Engine Harness Changes
MP7, MP8, US2014
CHU, CXU, GU, LEU, MRU

FSB 284-056, Engine Harness Changes

(April 2015)

W2100467

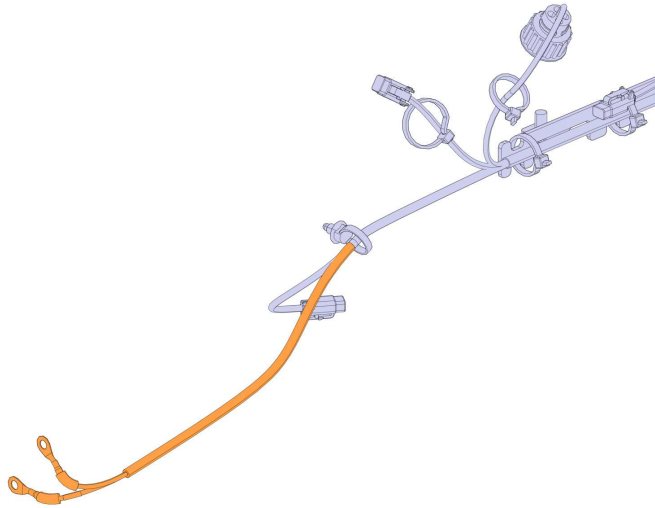
- **MP8 Engine Only:** Yellow marking tape added to crankcase pressure sensor wire. Blue marking tape removed from oil pressure sensor wire.

W2100052

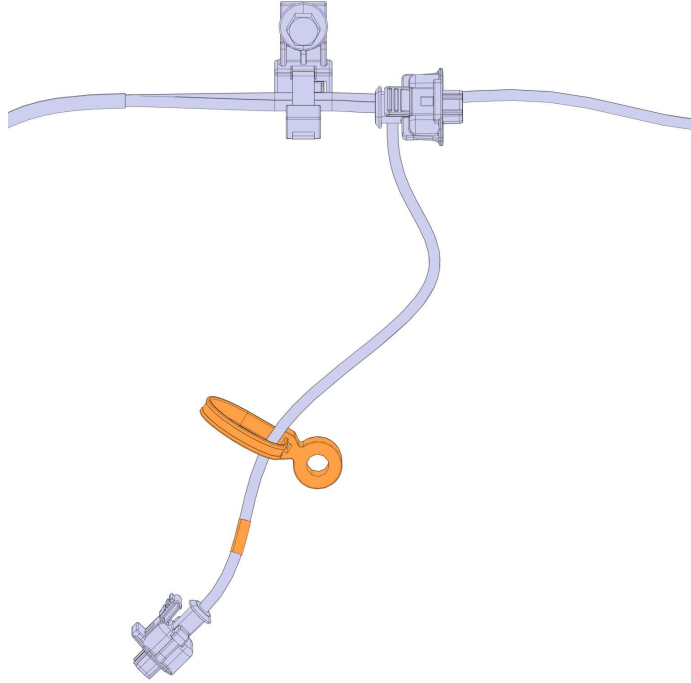
- The starter solenoid wires now come from the front. Previous starter wire routed around the cold side of engine around the rear.
